ADDENDUM No. 1

Project Name:	Owner: City of Dexter Project Name: Dexter City Hall Renovations	Addendum No: One (1)
Project Number:	21-113	Issue Date: January 21, 2022
Project Location:	3515 Broad St. Dexter, Michigan 48130

1st Floor Reflected Ceiling Plan - Area A
1/4" = 1'-0"

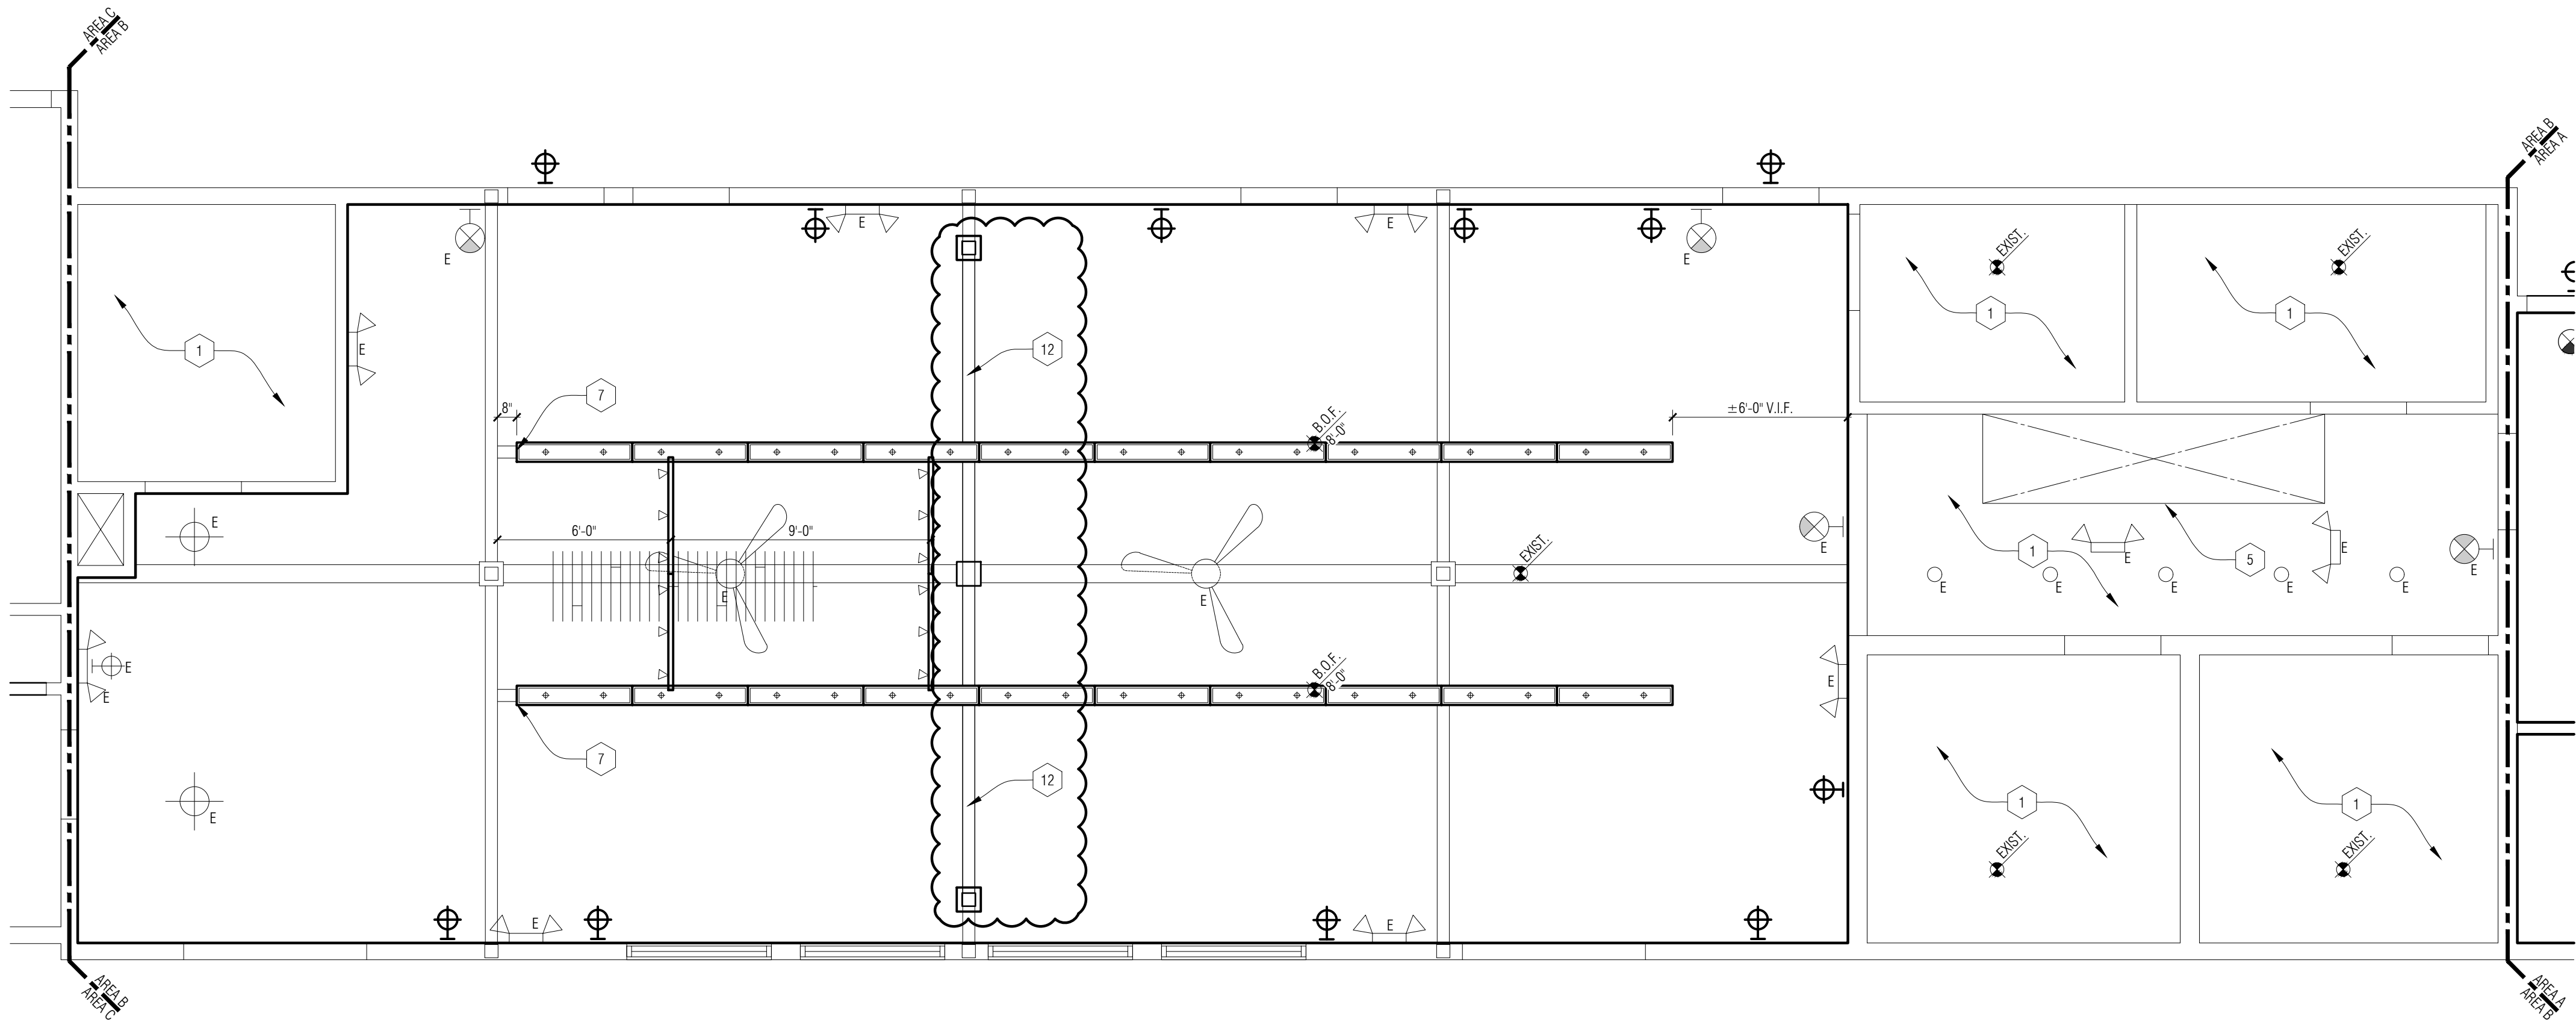
- A. Adjusted wall location for hoteling area to match update made on floor plan.
- B. Add surface mounted ceiling fixture @ existing low ceiling in Hoteling 103.
- C. Removed ceiling patch in Archive Storage 115, due to both lights now being existing to remain.
- D. Updated keynote 9 to clarify new wood beam finish is to match existing timber.
- E. Updated ceiling height of soffit above counter.

A4-03

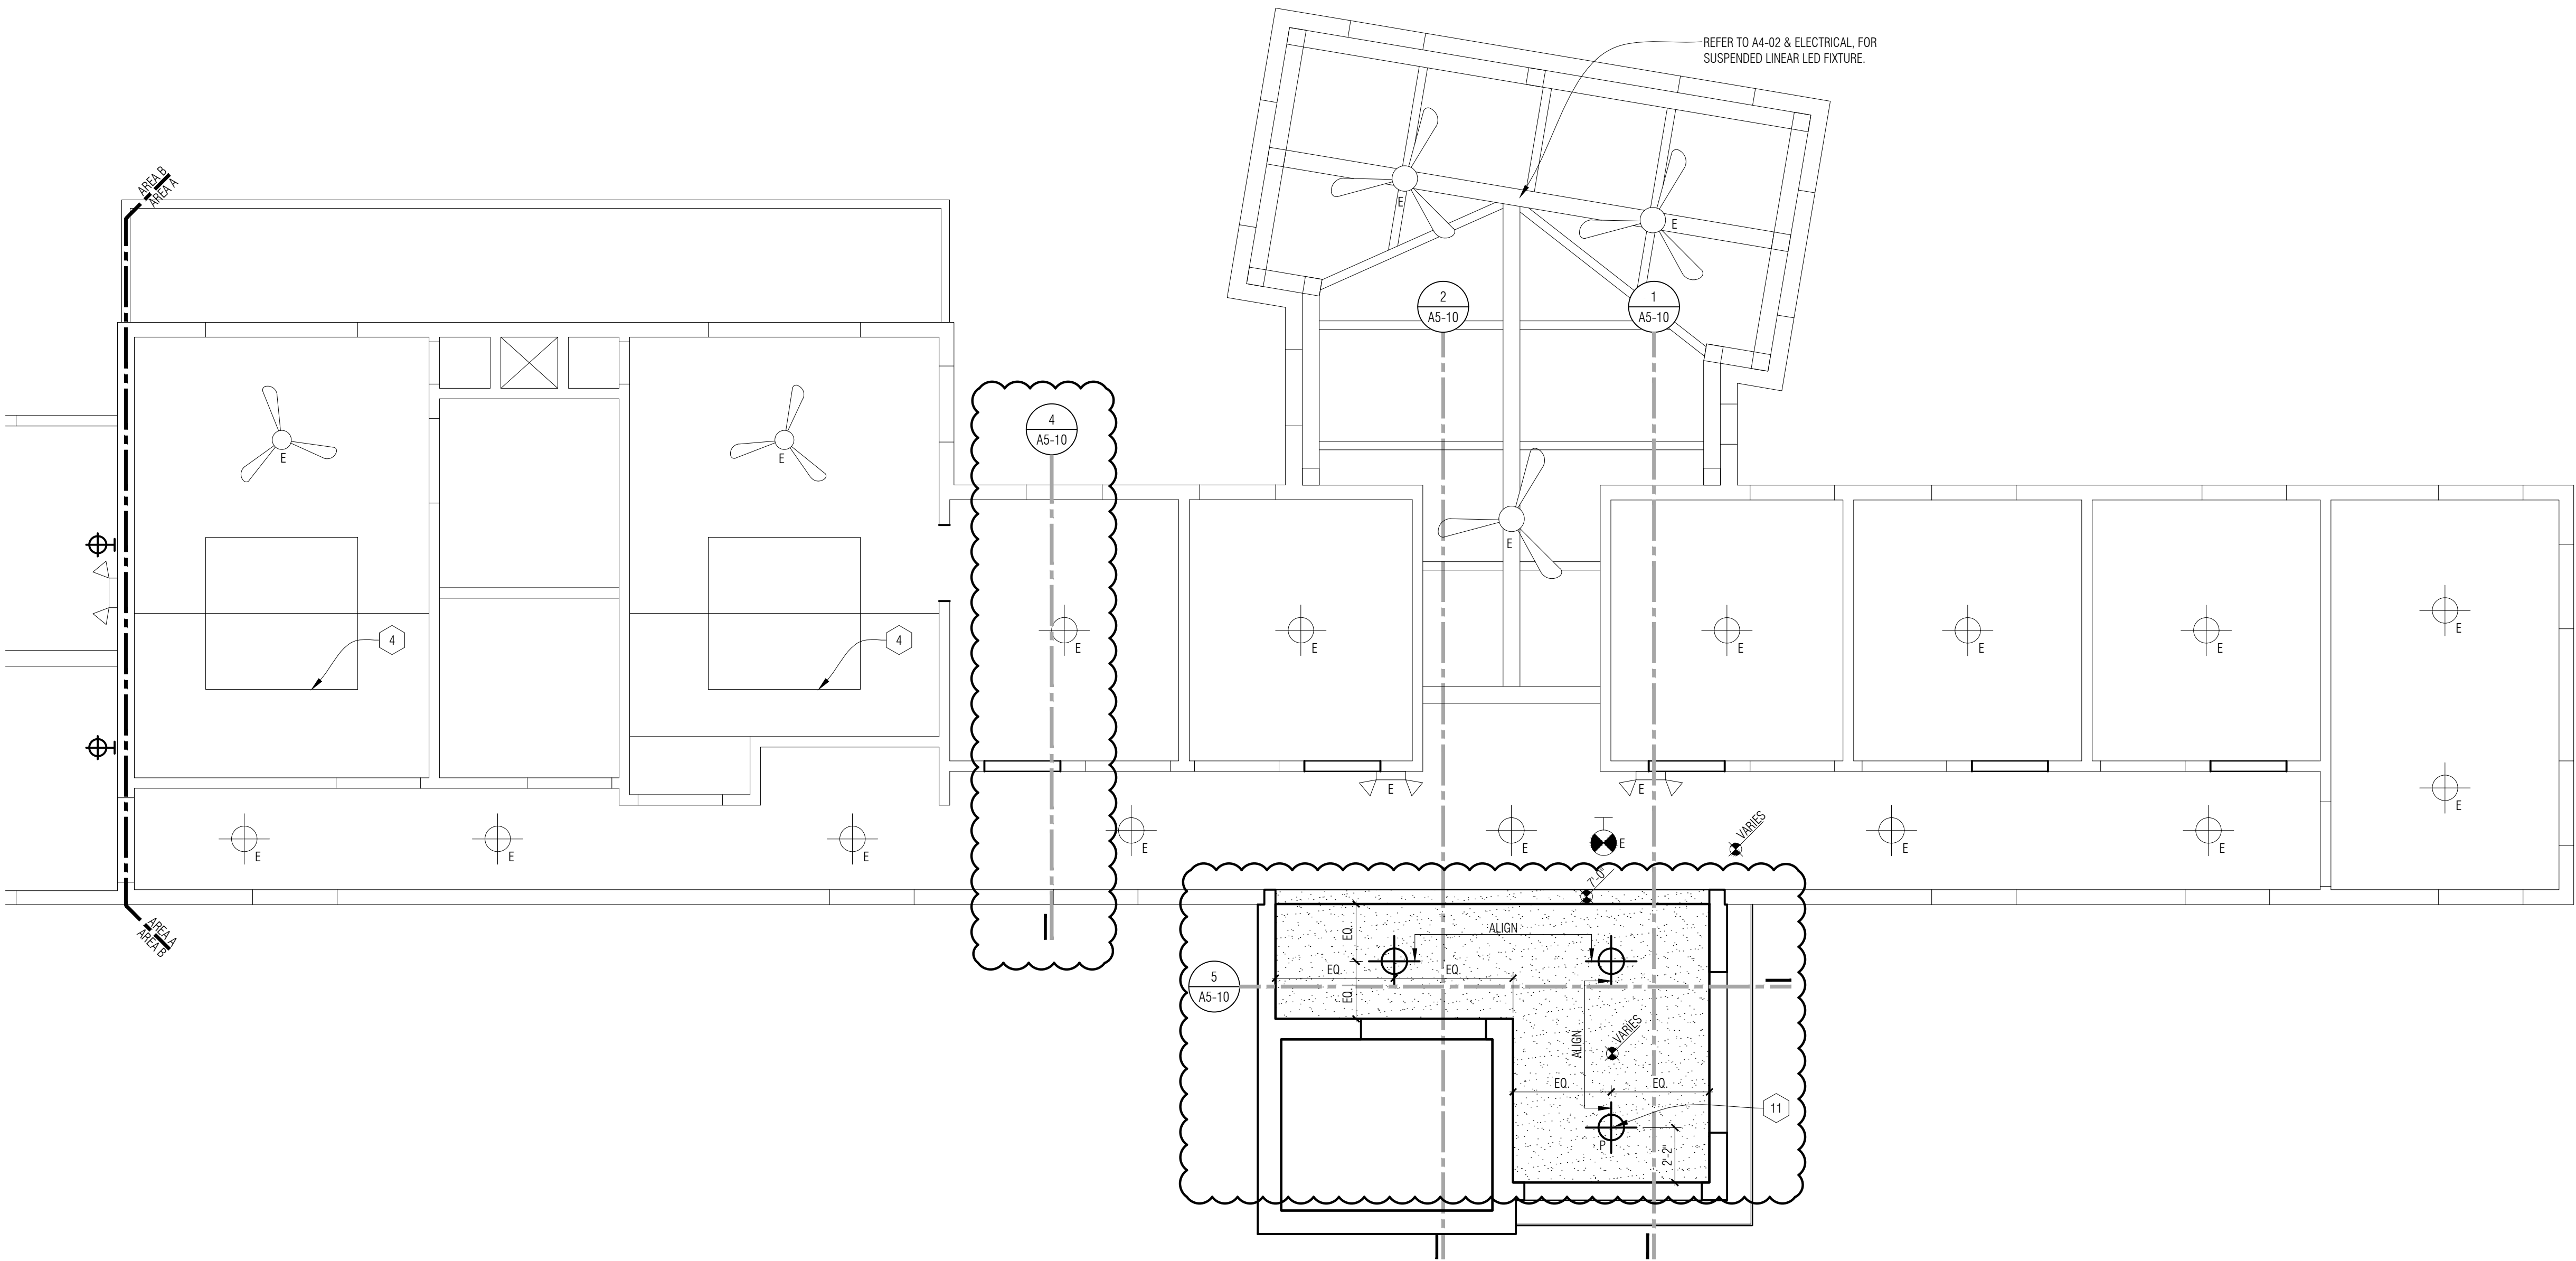
- A. Added callout for new beam under deduct alternate #3, and associated keynote 12.

A4-04

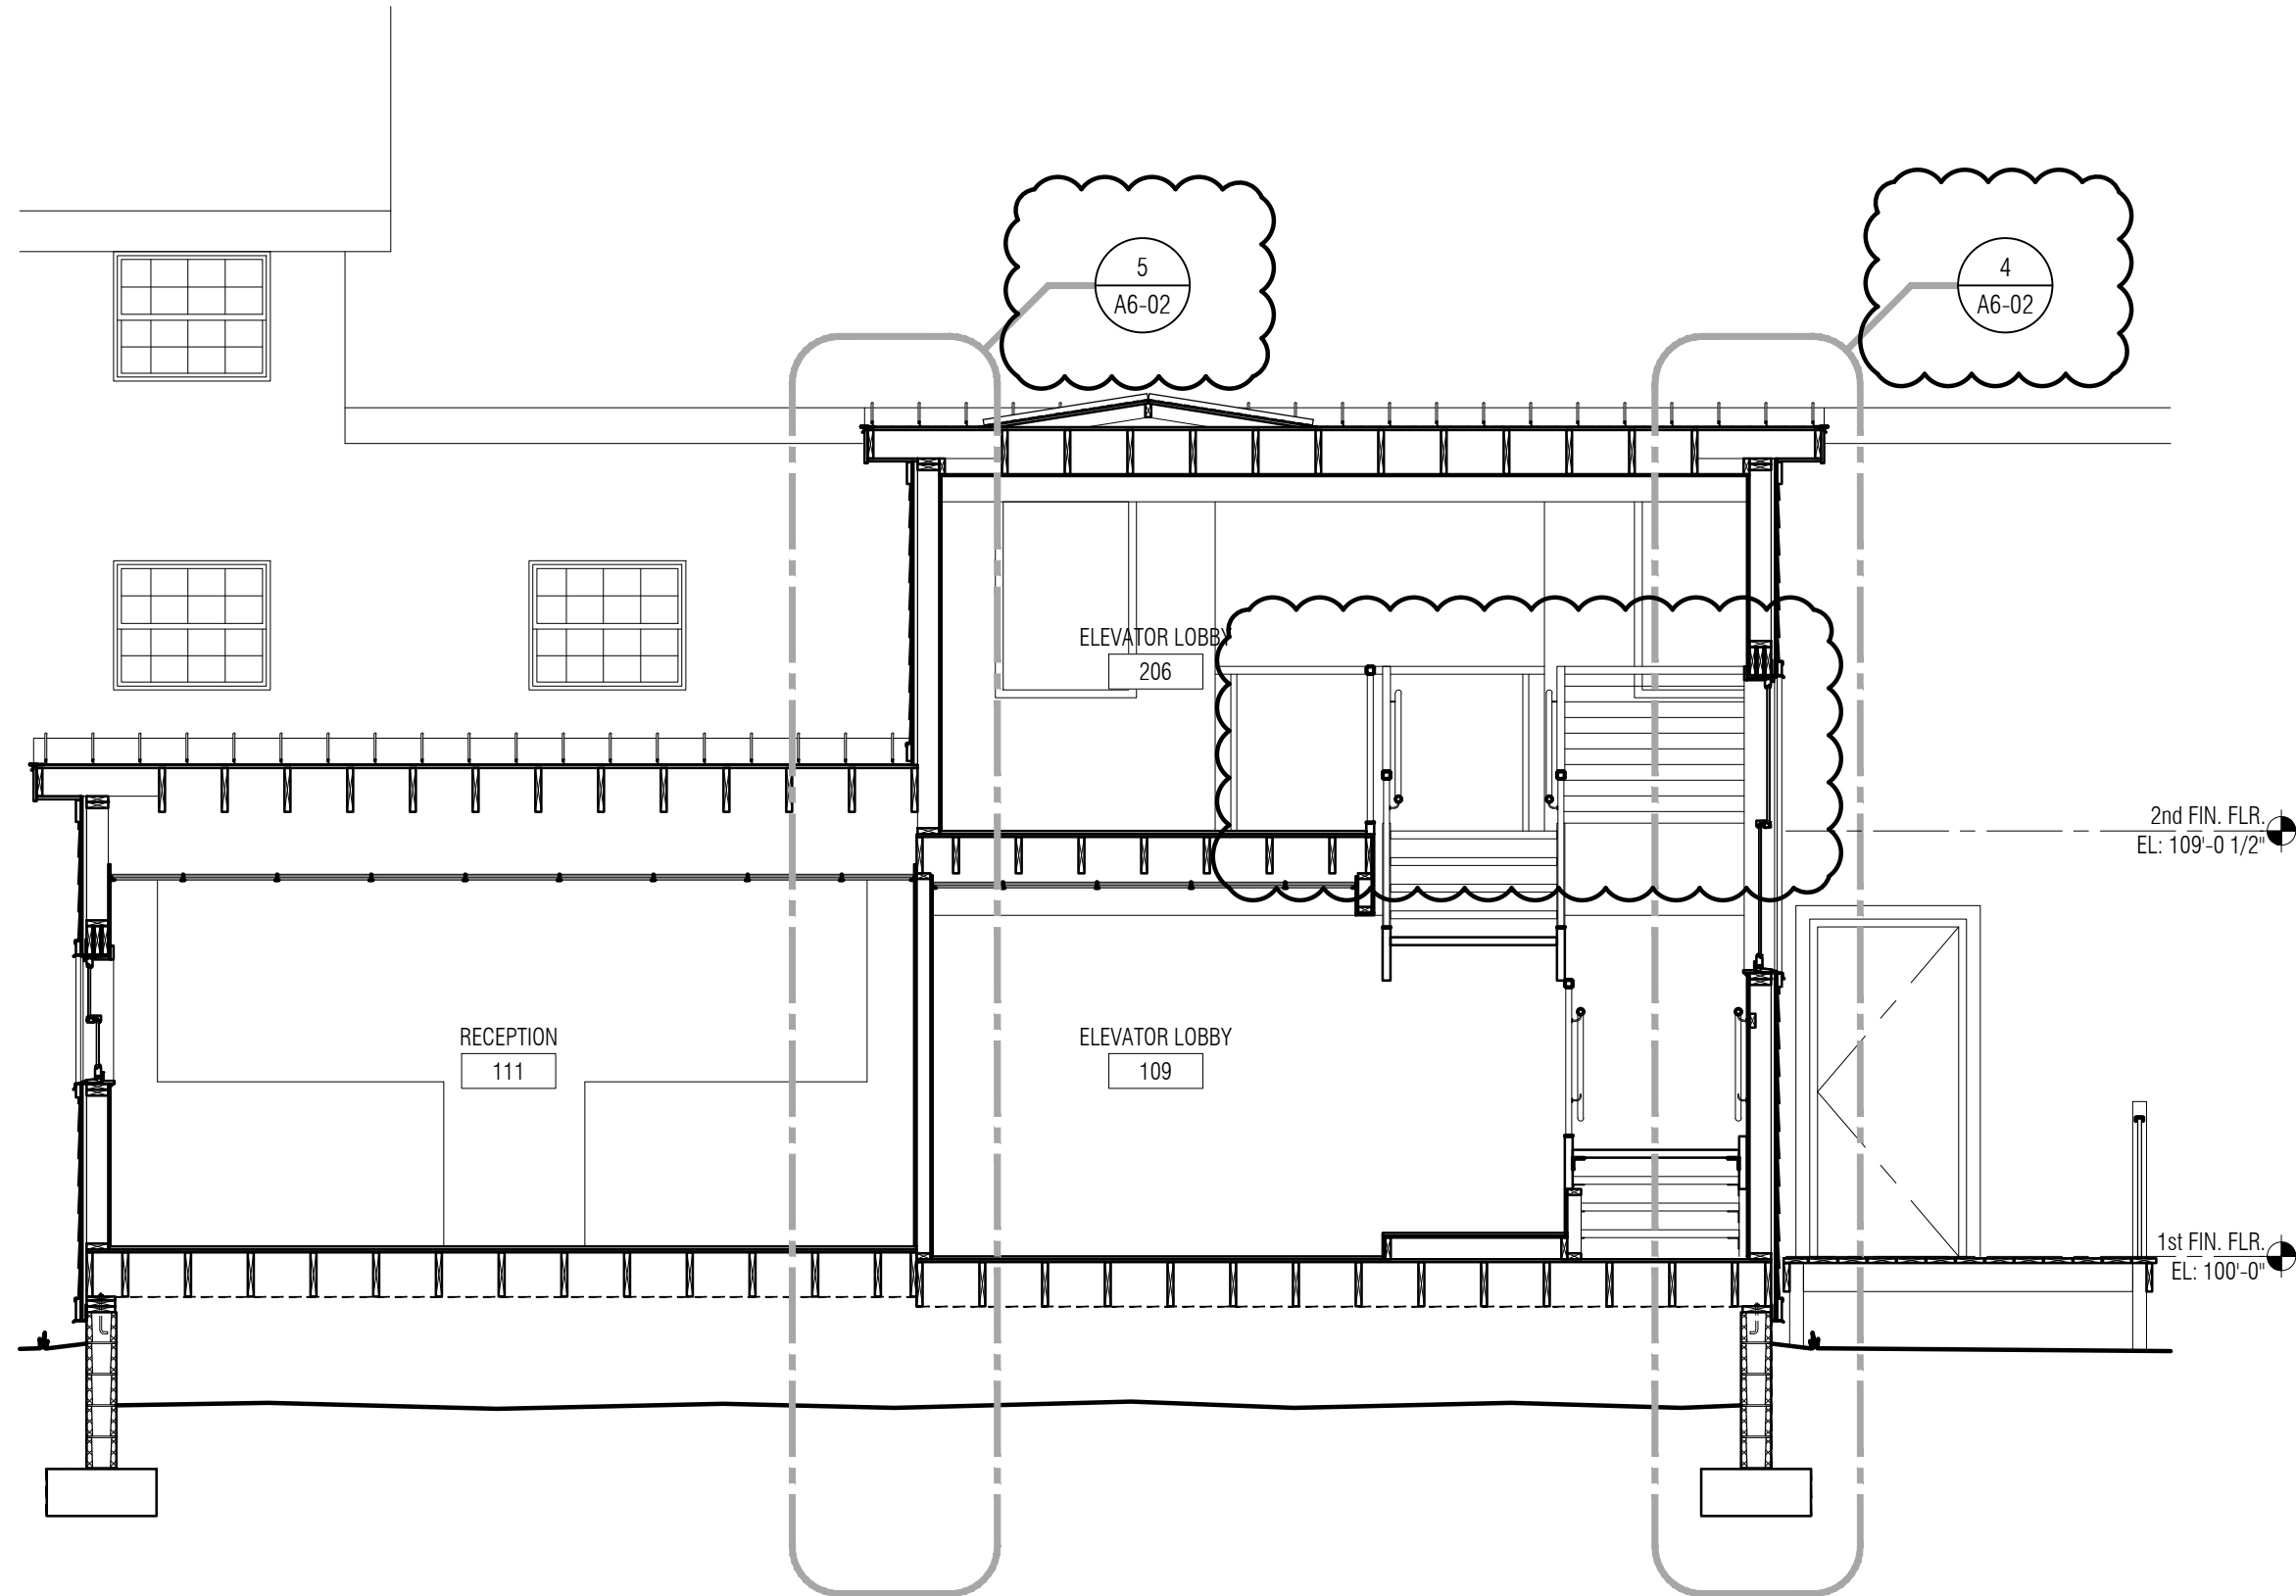
- A. Updated building section tag @ vestibule area to read detail 4, rather than 3.
- B. Added building section cut line through elevator lobby and stair area to match other plans.
- C. Updated lighting layout for elevator lobby and stair area.
